IL41x, BRT2x, VO41xx, VO306x OptoTRIACs green production line transfer

Product Change Notification

Product Group: OPT/Thursday September 3, 2026/PCN-OPT-1495-2026-REV-1

PCN OPT-1495-2026 Package Dimensions Comparison

DIP-6

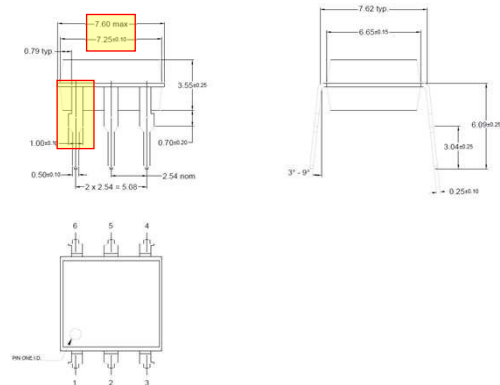
Note: major changes are the package length and the lead shape form

DIP-6, 400 mil (option 6)

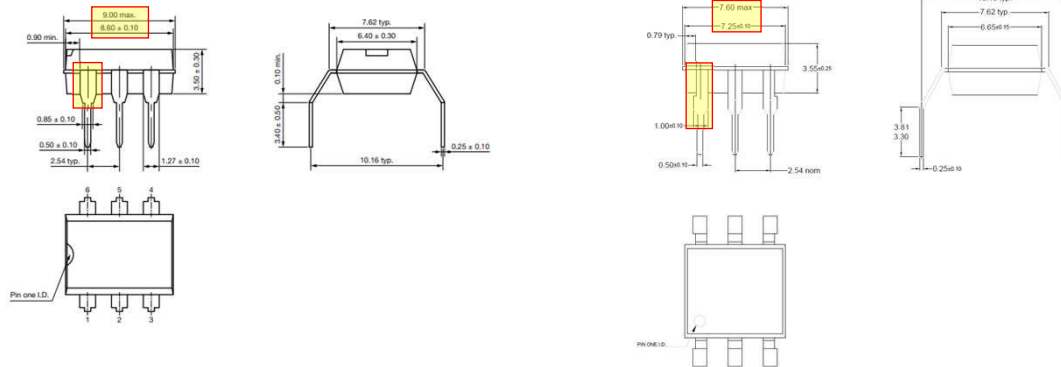
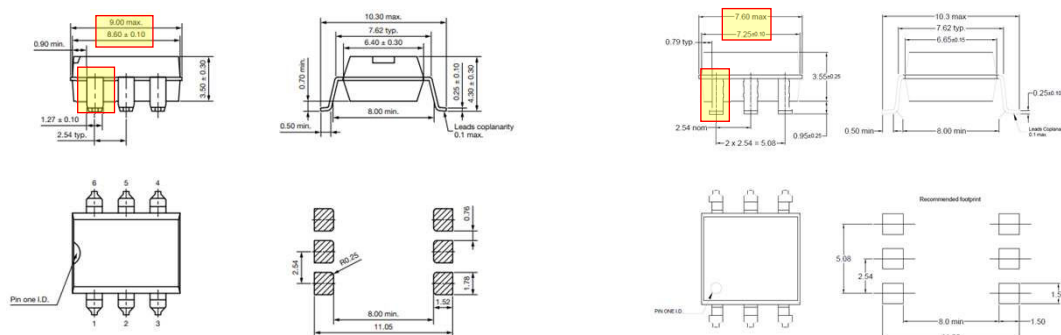
Note: major changes are the package length and the lead shape form

SMD-6 (option 7)

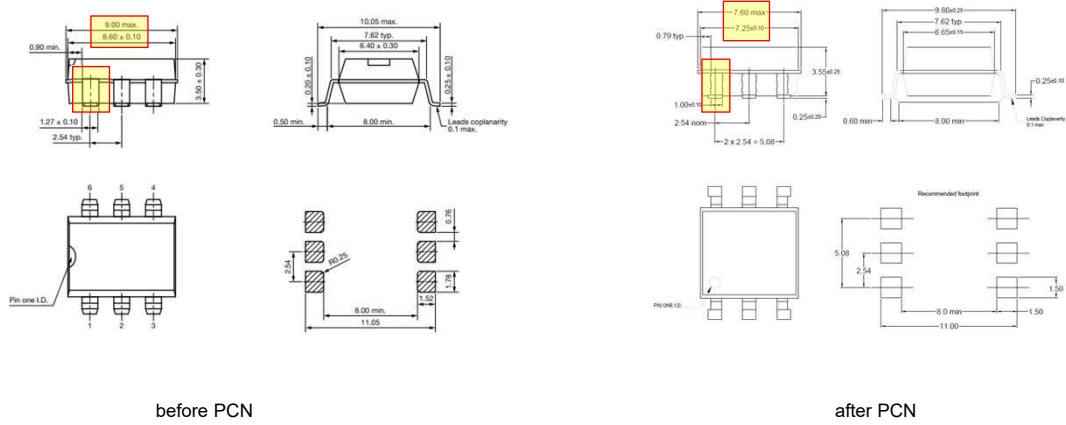
Note: major changes are the package length and the lead shape form
